Planning Commission Study Session

MEETING DATE: JUNE 3, 2020

SUBJECT: A. Z20-03 TRILOGY AT POWER RANCH: REQUEST TO AMEND ORDINANCE NO. 1450 TO AMEND THE CONDITIONS OF DEVELOPMENT WITHIN THE TRILOGY AT POWER RANCH PLANNED AREA DEVELOPMENT (PAD) FOR APPROX. 5.74 ACRES LOCATED AT 4369 E. VILLAGE PARKWAY AND ZONED PUBLIC FACILITIES/INSTITUTIONAL (PF/I) ZONING DISTRICT WITH A PAD.

B. DR19-128 (DR97-62-G), TRILOGY PICKLEBALL AND TENNIS RENOVATIONS

① FABRIC SHADE CANOPY (EAST SIDE) - PLAN
1/8" = 1'-0"

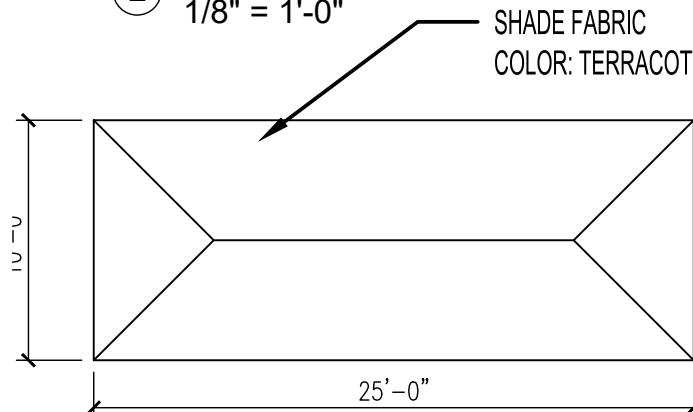
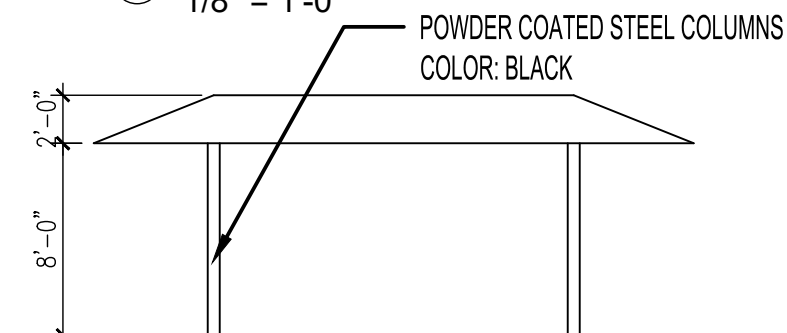
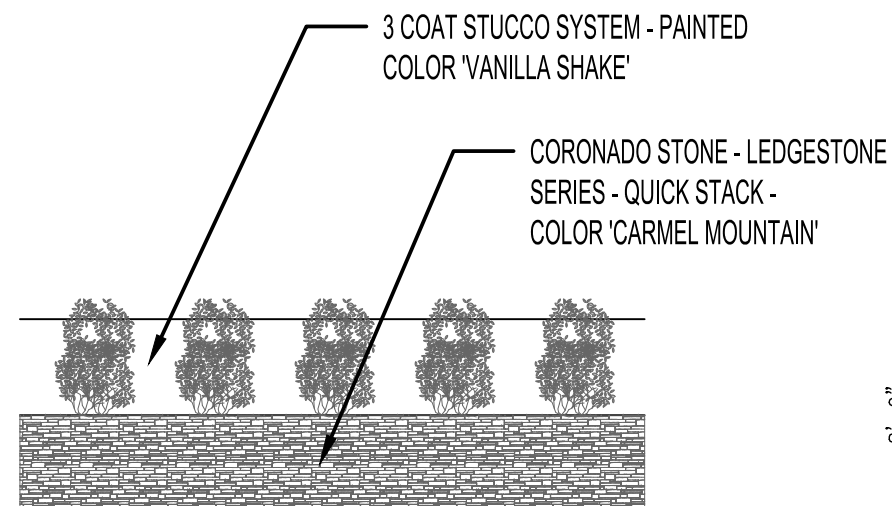
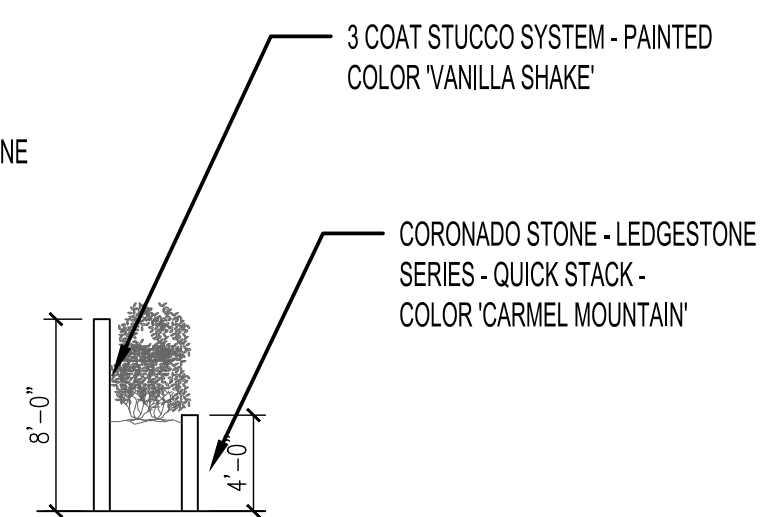
The proposed shade canopy, located between the pickleball courts, consists of a fabric canopy over black steel columns. Staff is concerned with the use of a fabric shade canopy and its durability.

⑤ SOUND WALL - ELEVATION
1/8" = 1'-0"

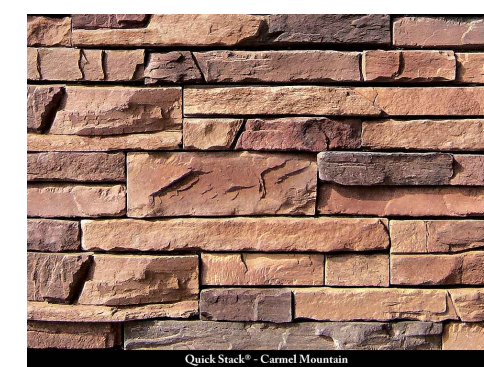
Finally, the applicant has completed a sound study to evaluate the noise impacts of the pickleball courts. As a result of this study and resident comment, a sound wall has been proposed on the eastern side of the site between the pickleball courts and the nearby residences. The sound wall is proposed to be 8' tall stucco wall painted to match the restroom buildings and incorporates a 4' stone retaining wall to provide a planter area for shrubbery.

SITE PHOTOMETRIC PLAN

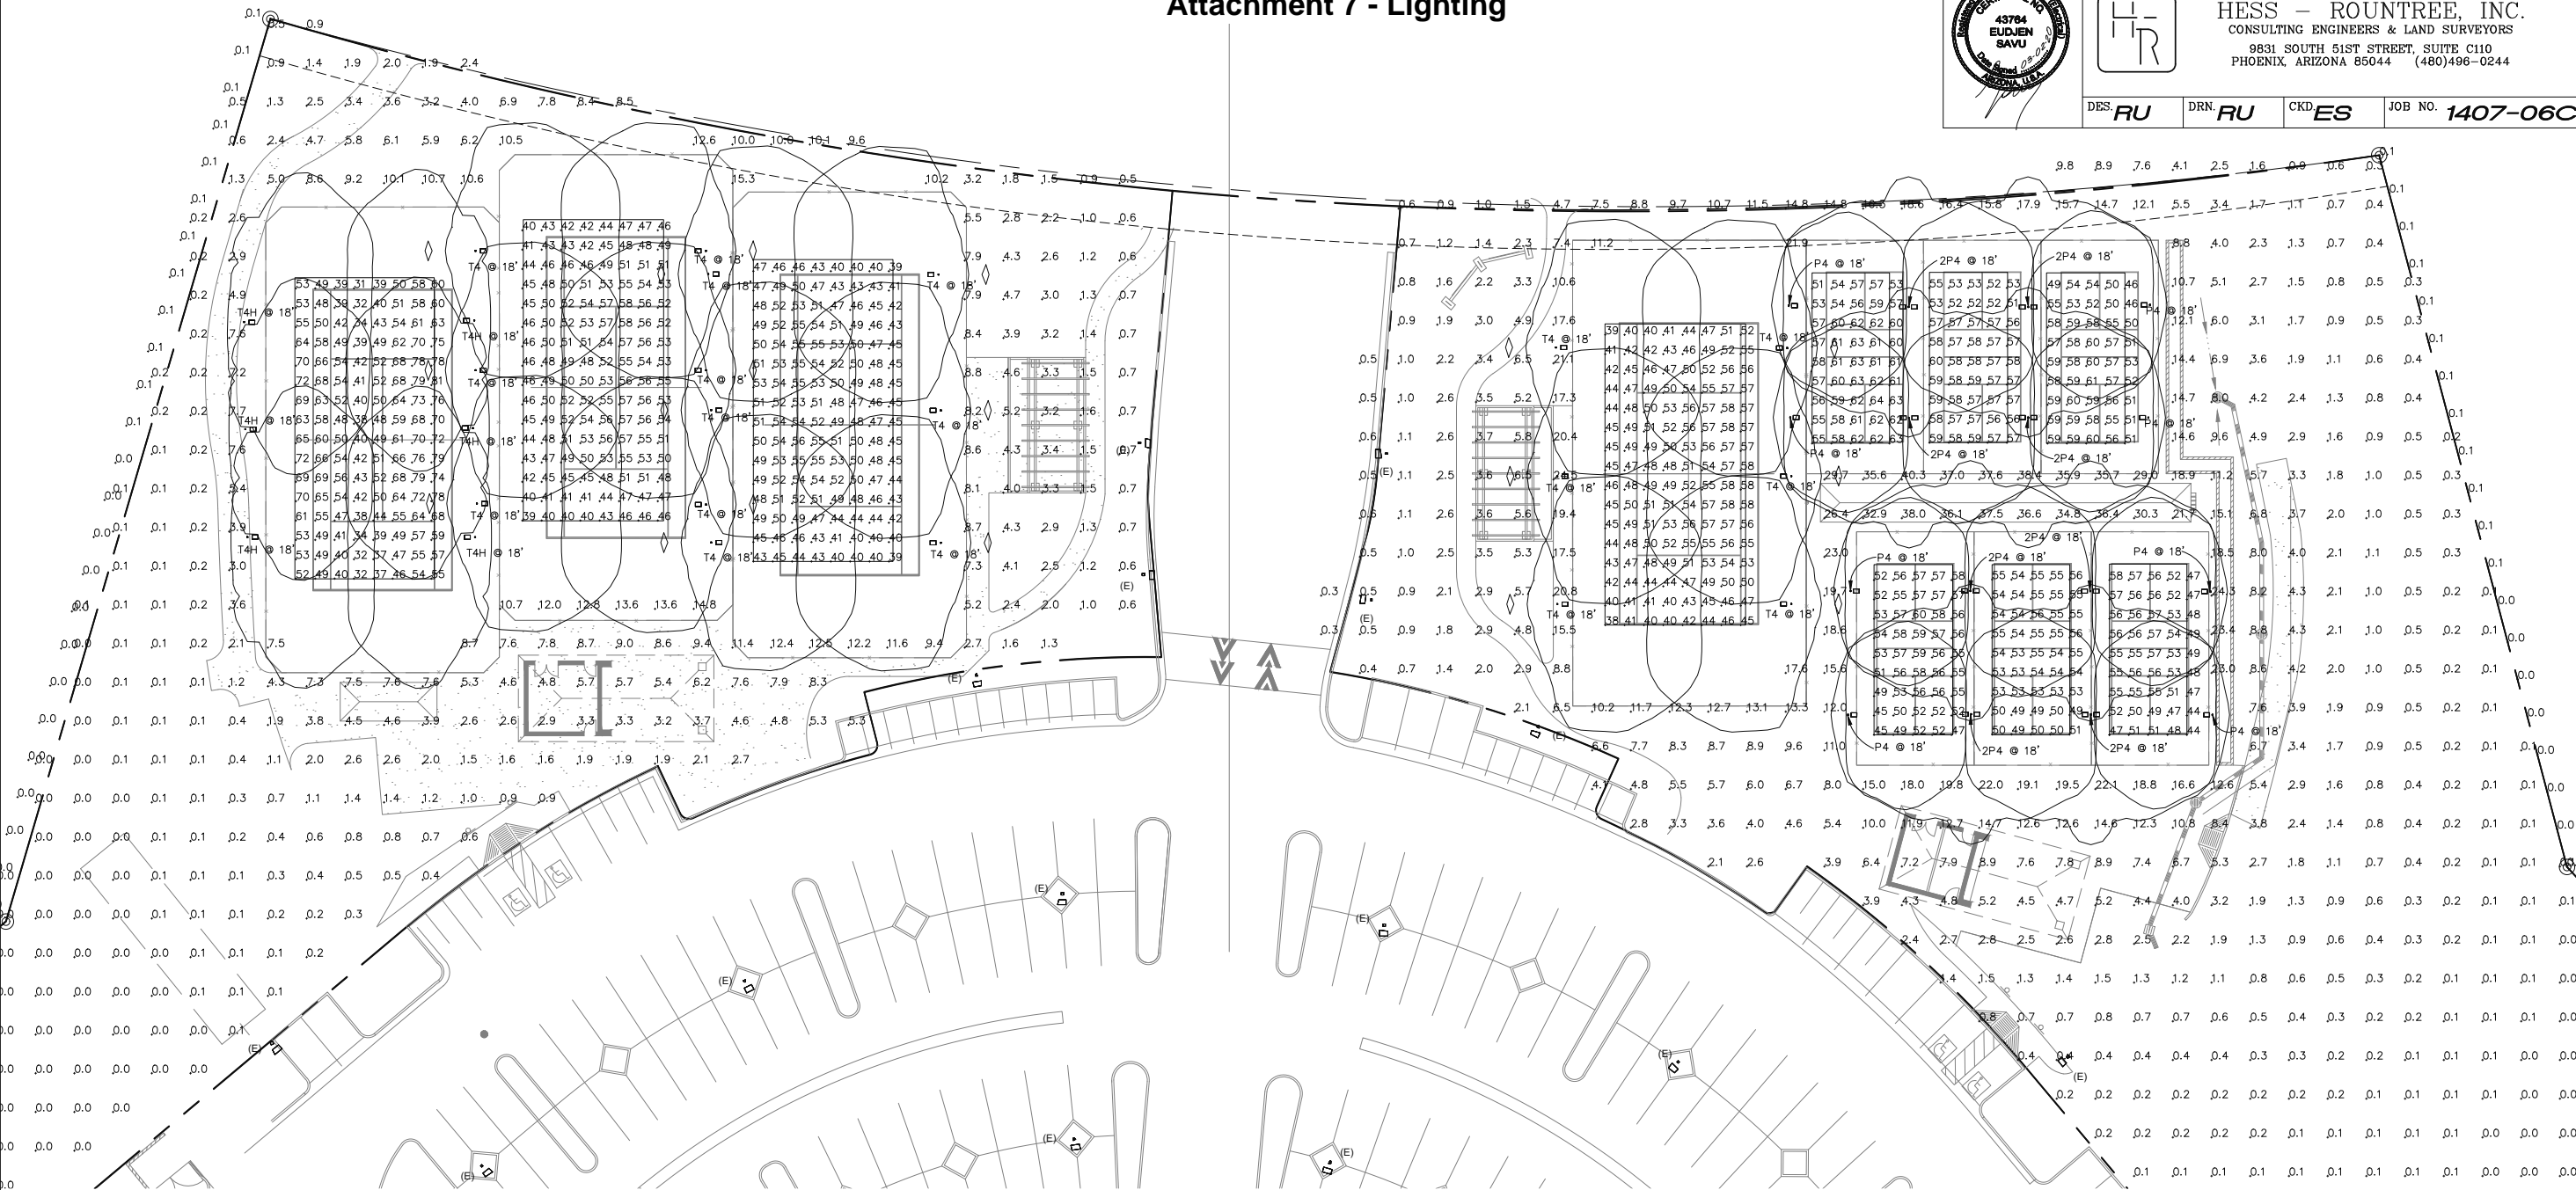
Lighting is proposed on all courts at a mounting height of 18'. LED area lights are proposed and incorporate house-side shields in proximity to the existing residences to reduce glare from the fixtures. In addition the applicant has complied with staff's request that the kelvin temperature of the lights not exceed 3000K to provide a warm white light that is easier on eyes.
